Approved SDS changes to VSG-0000-PL-U1100 shown in cloud

**APPROVED CHANGES to VSG-0000-PL-V1302**

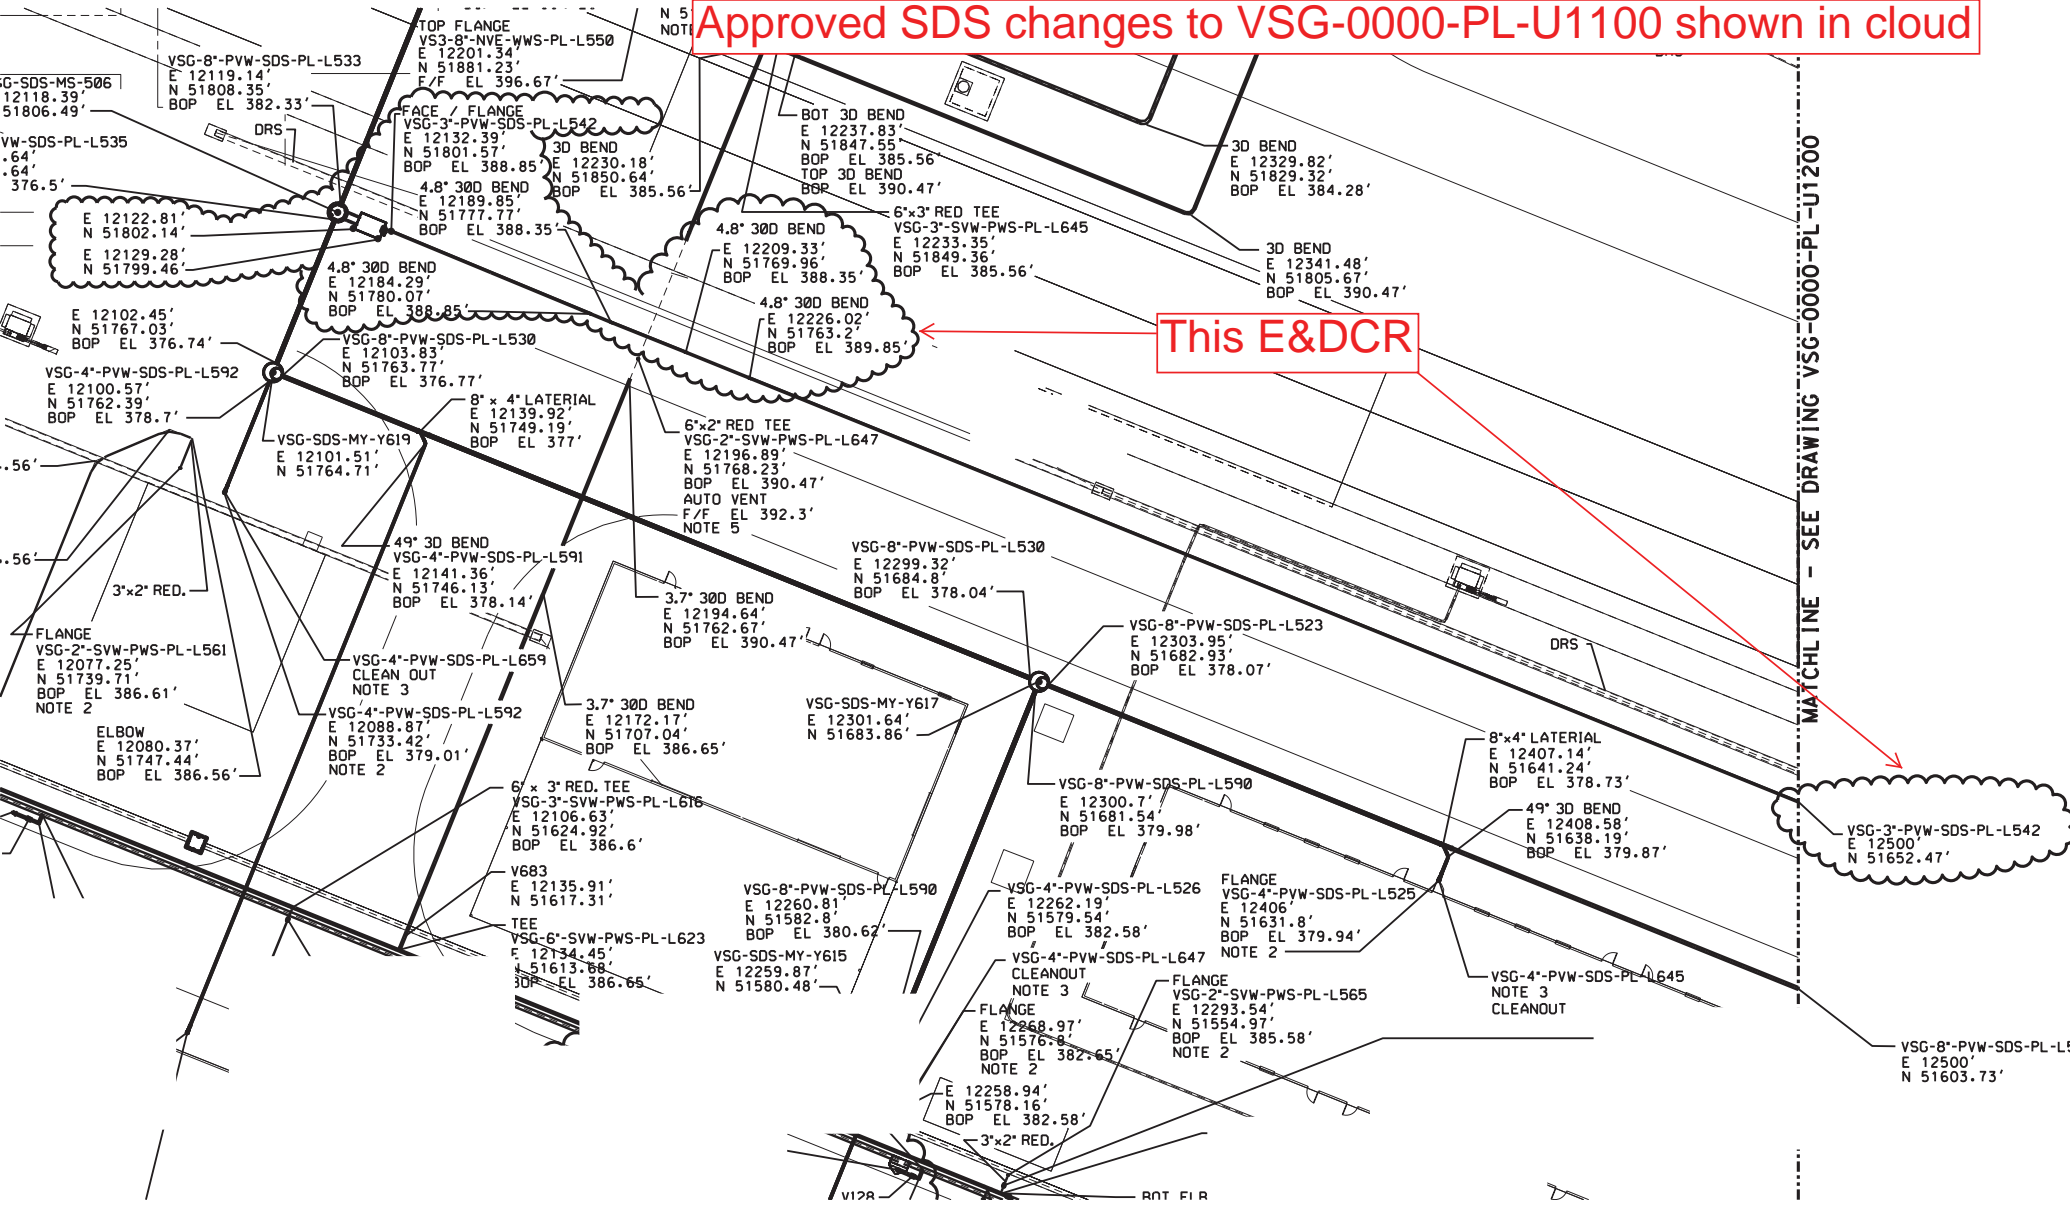
This E&DCR
